**From:** "Suttora, Linda" <Linda.Suttora@em.doe.gov>  
**To:** "Xiaosong Yin" <XXY@nrc.gov>  
**Date:** 06/29/2006 12:42:21 PM  
**Subject:** Response to additional questions

Follow-up Items from June 1, 2006, Meeting with DOE on INL TFF Waste Determination

As committed by NRC staff at the conclusion of the June 1, 2006, meeting, the following list of follow-up items that require a response from DOE was provided. Information requested is based on the questions provided to DOE for this meeting as well as NRC's Request for Additional Information (RAI). DOE has provided responses following each request for information.

Figure F-28. Releases of  $^{241}\text{Pu}$  from the sandpad and tanks (DOE/ID-10966).

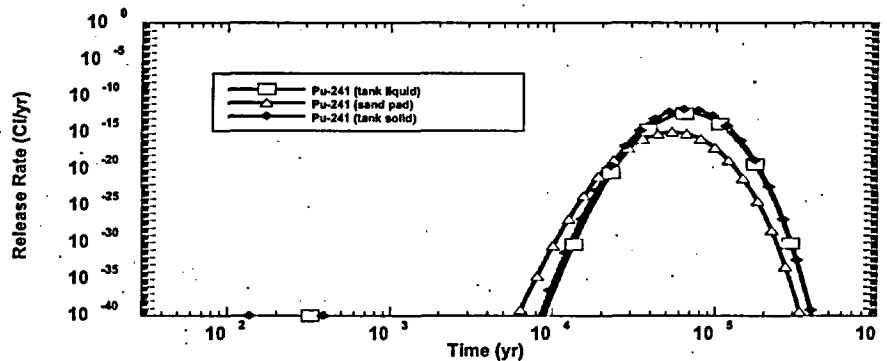
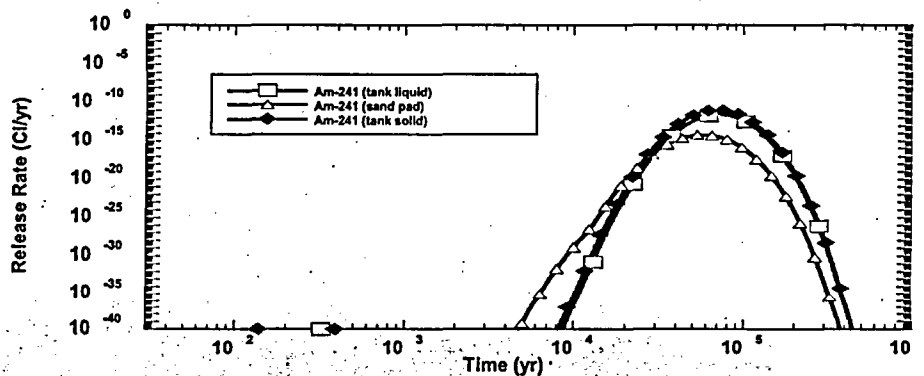
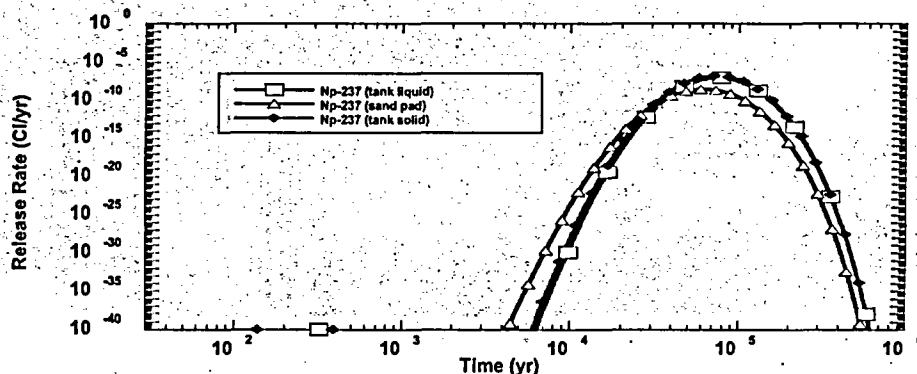
*DOE-ID should provide the  $K_d$ s used for Np-237 in the screening analysis, since DOE did not perform additional modeling of release and transport of Np-237, although the uncertainty in the inventory of Np-237 was much greater than it was for other modeled constituents in response to RAI #4.*

The screening values for the tanks, provided in Table 3-2 of the PA were based on the grout  $K_d$ . The screening values for the sandpads, provided in Table 3-3 of the PA, were based on the sand  $K_d$ . The screening results provided in Tables 3-2 and 3-3 of the PA show that these radionuclides were not excluded during the first screening iteration. Therefore, contaminant release modeling was conducted using DUST-MS to evaluate the release from the tank/vault system. The results of this screening are provided in Figures F-28, F-29, and F-30 of the PA (shown below).

The controlling factor in the release of  $^{241}\text{Pu}$ ,  $^{241}\text{Am}$ , and  $^{237}\text{Np}$  from the tank/vault system is the grout  $K_d$ . The concrete  $K_d$  values for both oxidizing and reducing conditions are the same for  $^{241}\text{Pu}$ ,  $^{241}\text{Am}$ , and  $^{237}\text{Np}$  (i.e.,  $5 \text{ m}^3/\text{kg}$ ). The sandpad contaminants must pass through approximately 2 ft of the concrete vault floor. Figures F-28, F-29, and F-30 show the releases are delayed to approximately 10,000 years post-closure. Since the release of these contaminants was beyond the compliance period, no further modeling was conducted.

Figure B-12, West-to-east (north end) deep fence diagram.

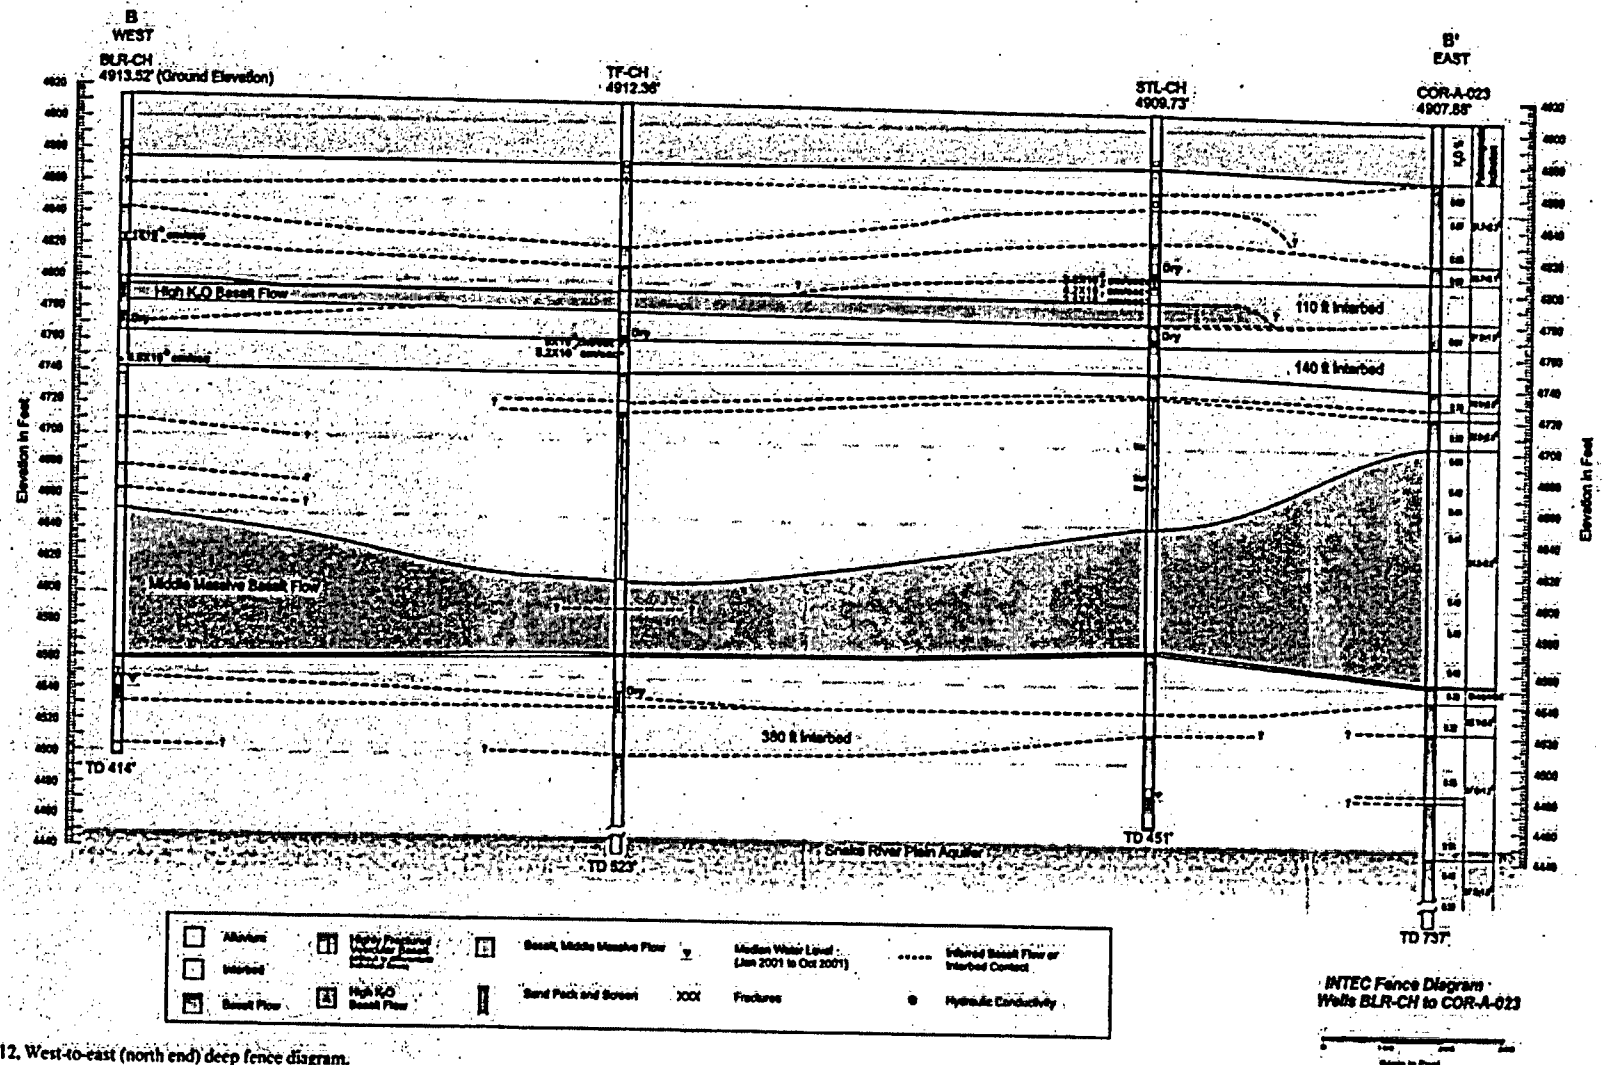
*DOE-ID should provide the reference that contains a new west/east geologic cross-section B-B' that is illustrated in Figure 3-4 of "Evaluation of Tc-99 in Groundwater at INTEC: Summary of Phase I Results" (ICP/EXT-04-00244). The reference from ICP/EXT-04-00244 that contains this cross-section is "Phase I Monitoring Well and Tracer Study Report for Operable Unit 3-13, Group 4, Perched Water," DOE/ID-10967, Revision 1, 2003. DOE-ID did not provide the most recent geologic cross-sections for the study area in response to NRC RAI 12.*

Revision 1 of DOE/ID-10967 (2003) is classified as "Official Use Only," which restricts its release to the public. A more recent revision, Revision 2, of this document is also classified as "Official Use Only." The requested cross-section (Figure B-12) has been cleared for release and is provided below. The cross-sections in DOE/ID-10967 are not considered to be more accurate than the Anderson cross-section used in the PA; the cross-sections are considered to be an additional interpretation of the geologic profile at INTEC.

The authors of the DOE/ID-10967 cross-sections note the following: "The cross-section correlations are interpretations based on individual well/borehole stratigraphic columns. Correlation of basalt flows and sedimentary interbeds between well locations without paleomagnetic, geochemical, K-Ar age dates, or petrographic data is possible but lacks a large degree of confidence." The authors also note that a detailed and accurate stratigraphic correlation beneath INTEC may not be possible given the currently available data. Collection of sufficient data to enable this accurate correlation would be cost-prohibitive.

Figure 1. Depiction of the locations of sedimentary interbeds at the INTEC Tank Farm Facility.

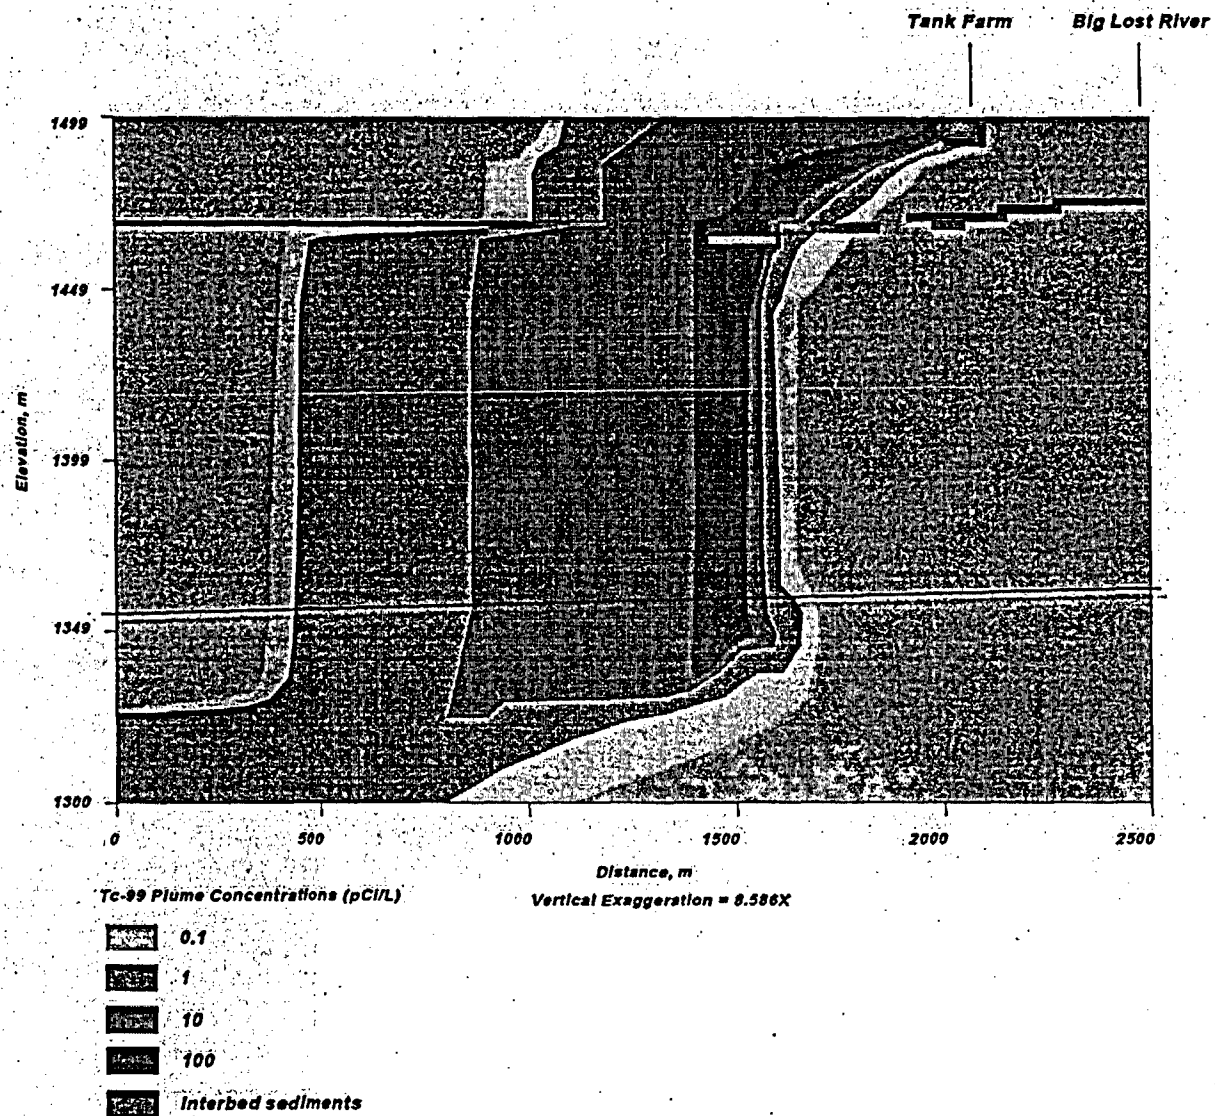
*DOE-ID should provide a new figure that shows an accurate depiction of the locations of sedimentary interbeds as shown in Figure 4-2 in the PA (the location of the sedimentary interbeds depicted on this figure is not consistent with Figure 2-12 in the PA).*

A new figure is presented below as Figure 1, which shows the correct interbed location in Figure 4-2 of the PA.
